Septic Alteration Plan Review

Block – 12201 AKA 83, Lot – 1 AKA 16&19

Jackson Township

SEPTIC ALTERATION PLAN

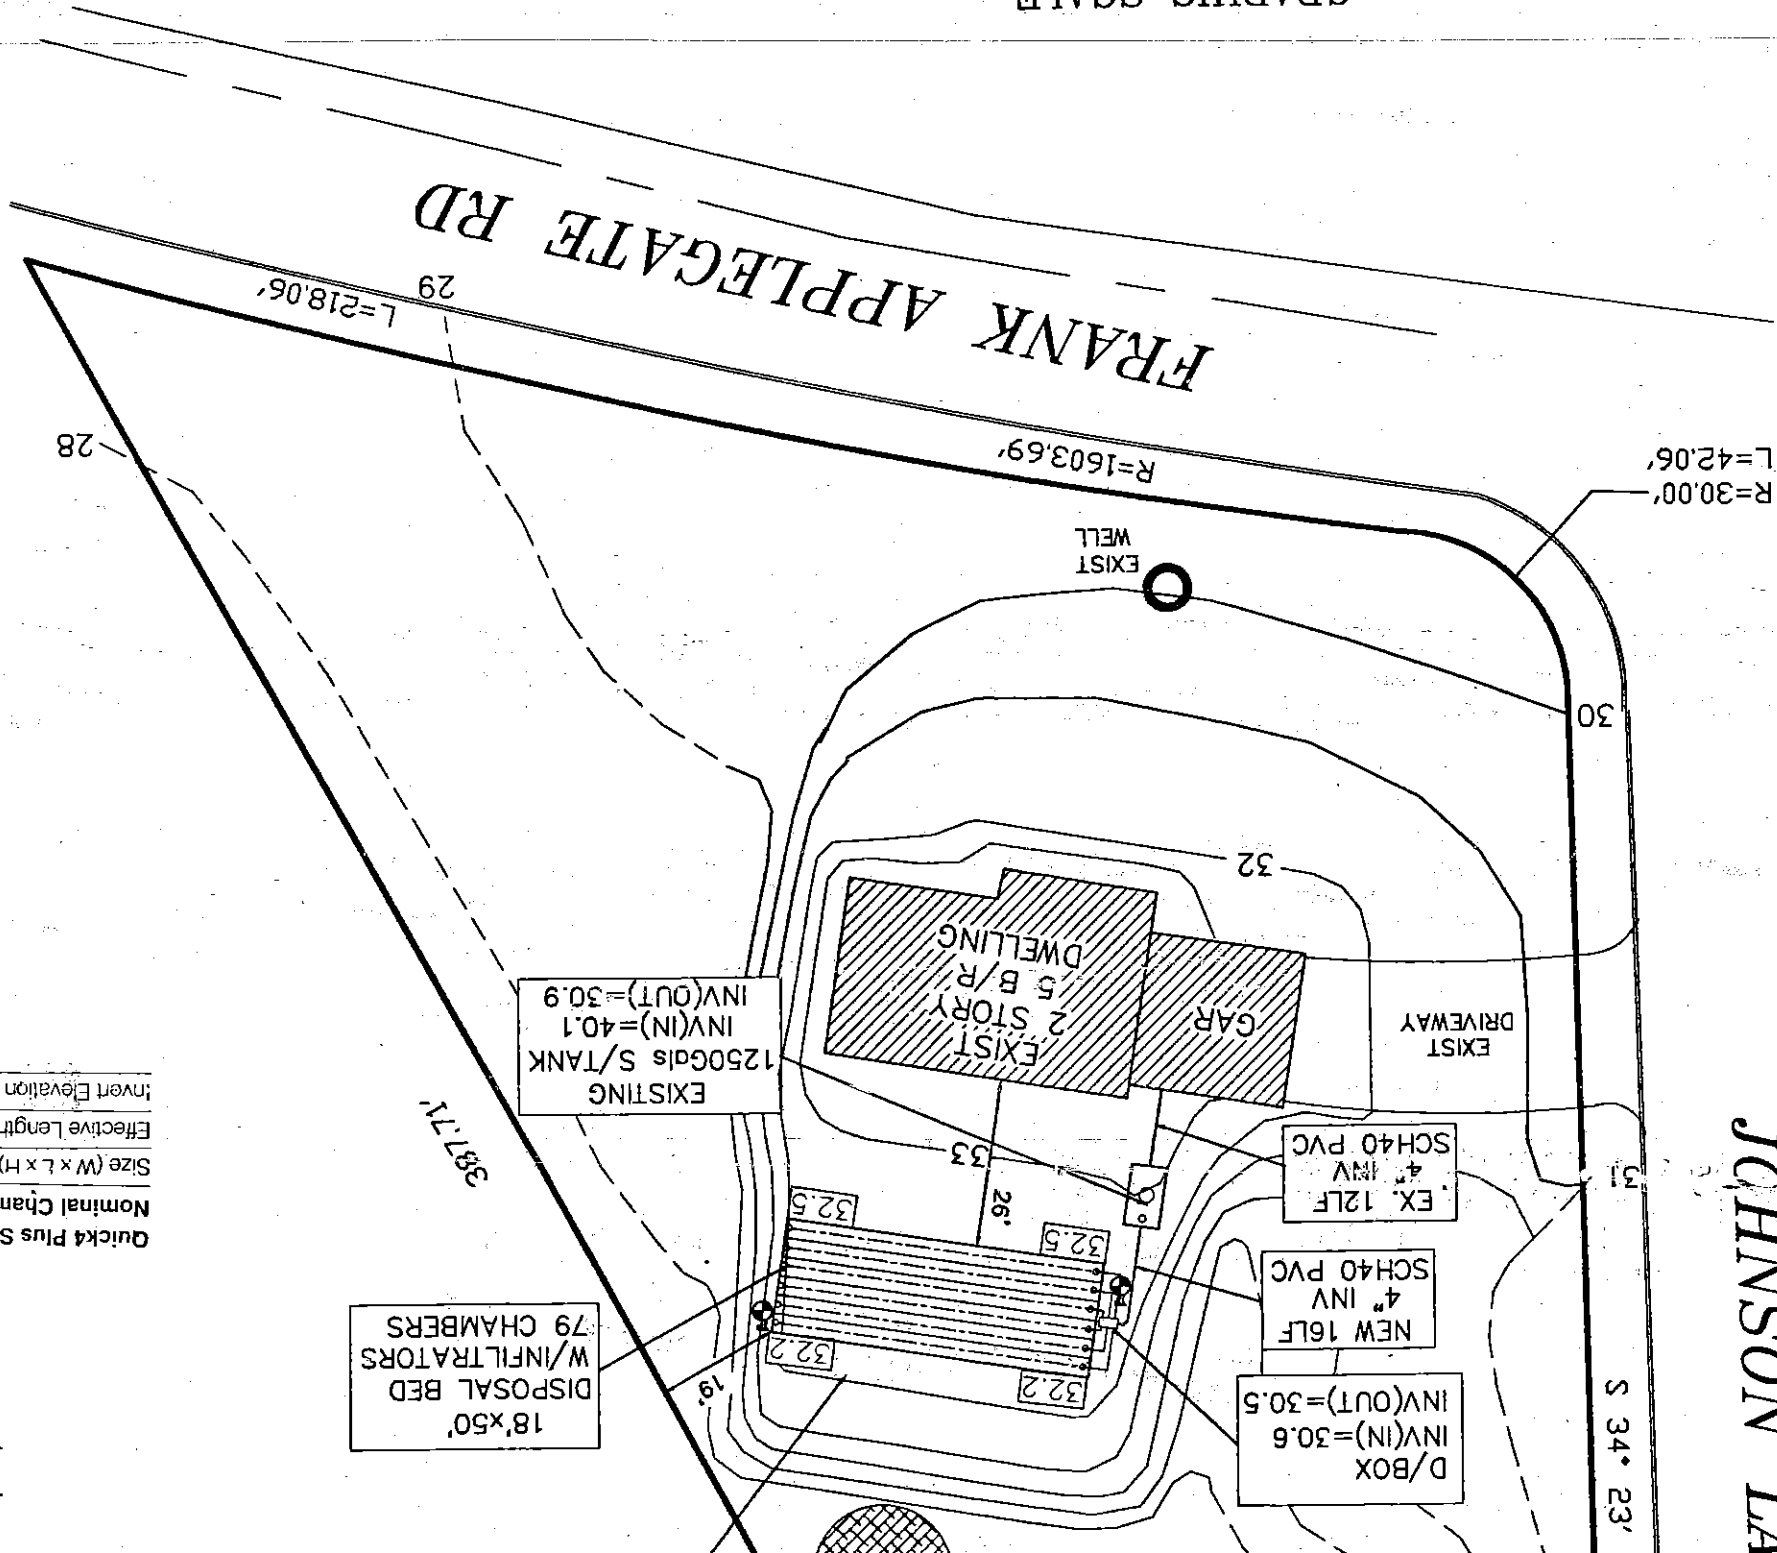
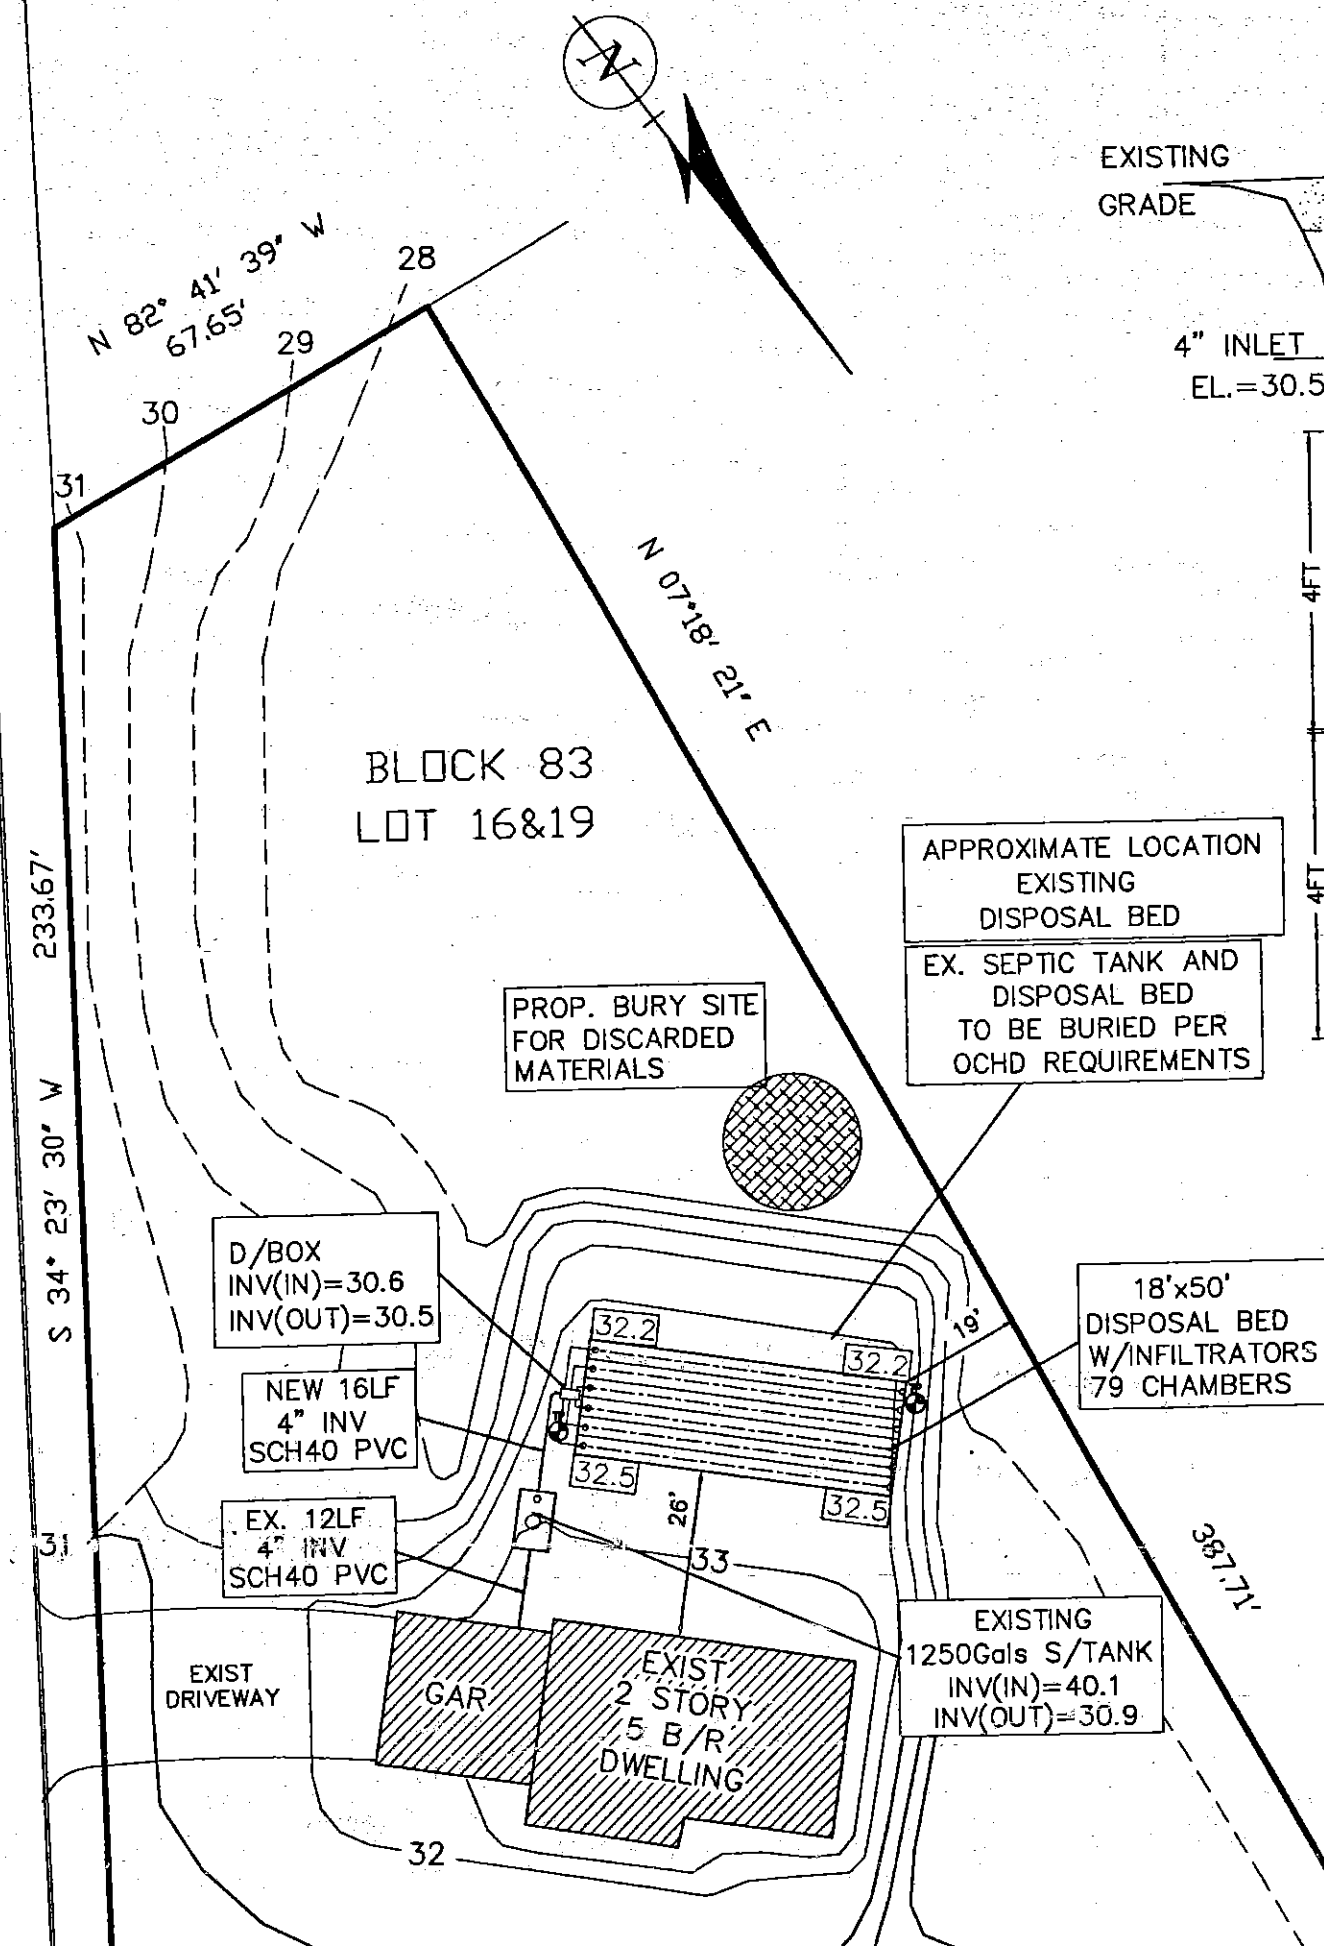
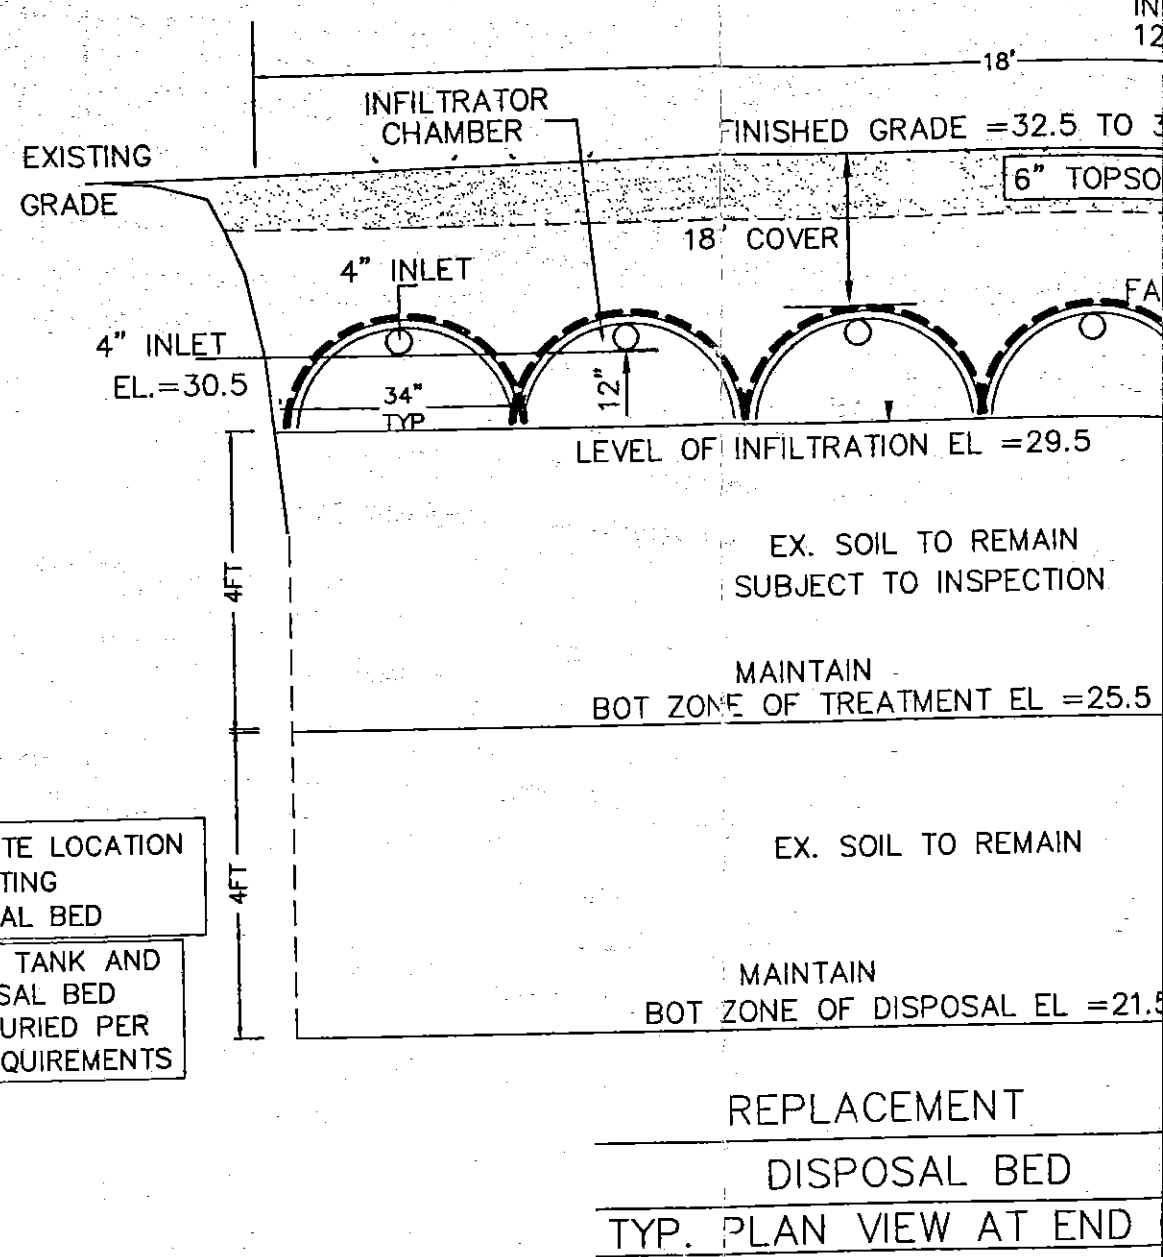
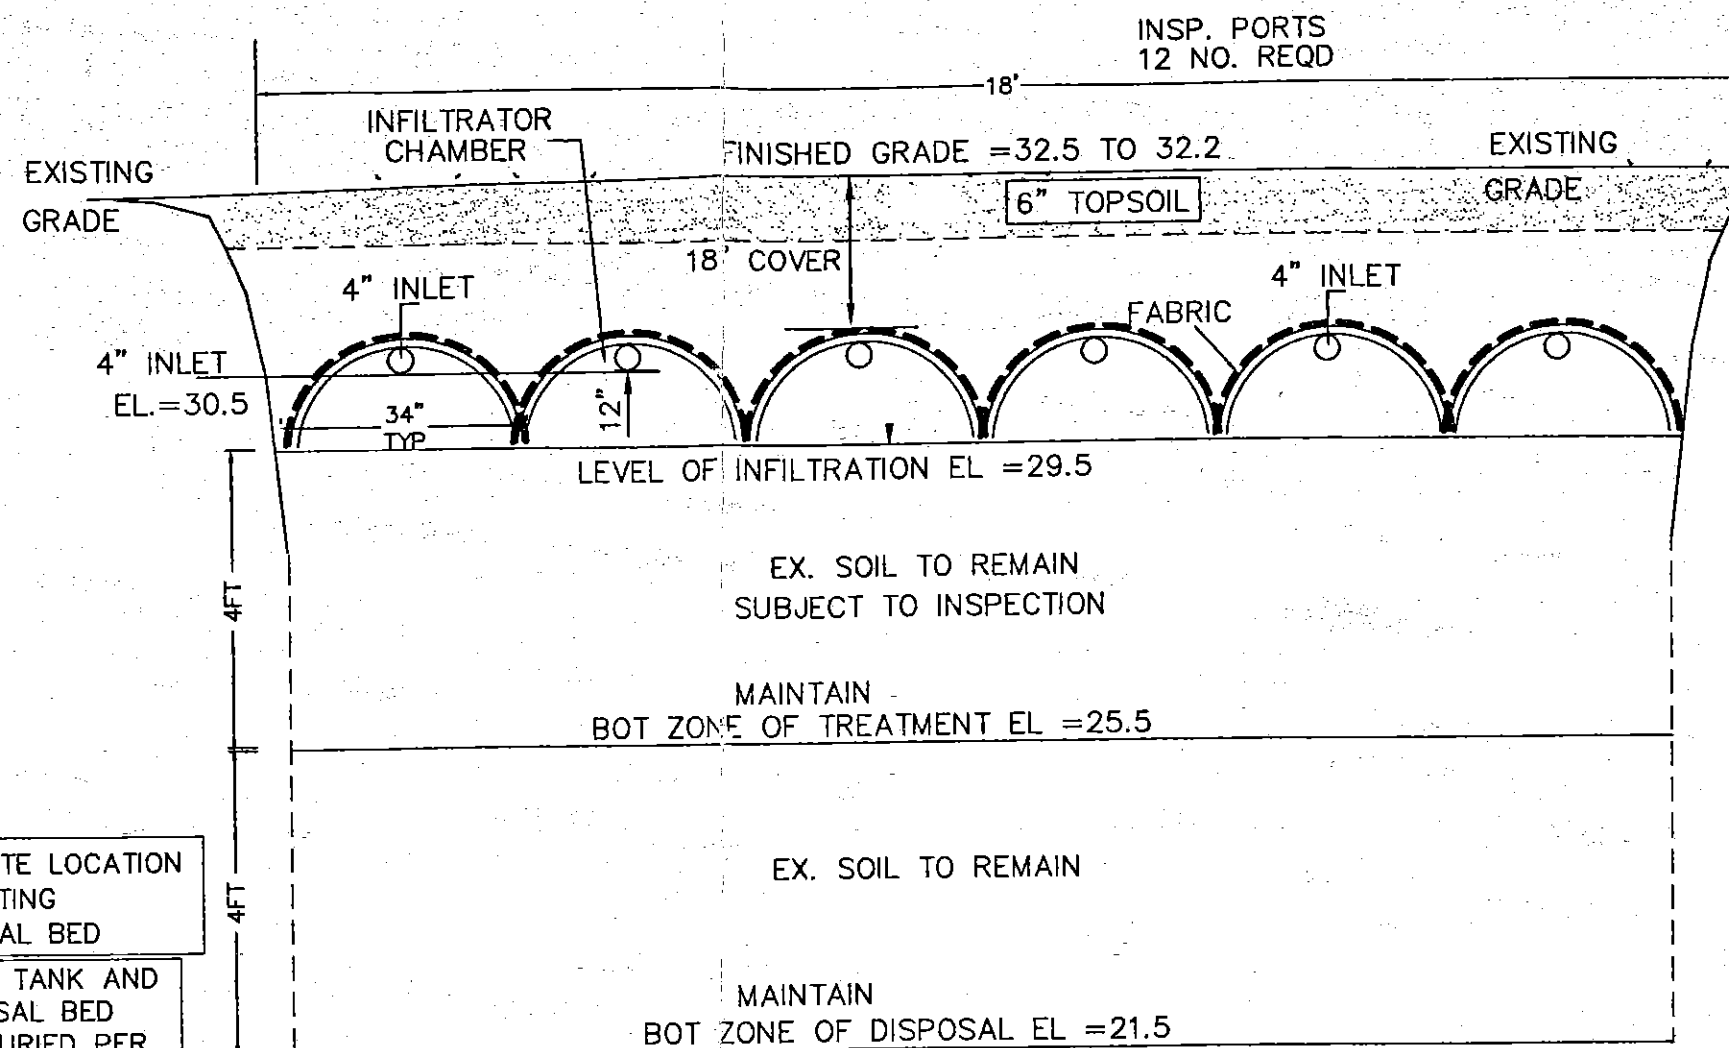
7:9A - 5.1 - Soil data required with application.

7:9A - 3.5(c) Please include a copy of TWA # 04-3487-4SG with your application. This Guidance document indicates the requirements of a reduced sized chamber system.

The site plan must delineate a disposal area sized at 100% of that which is required by Table 10.2(b) 10.2(b) or Table 10.2(c), for example.
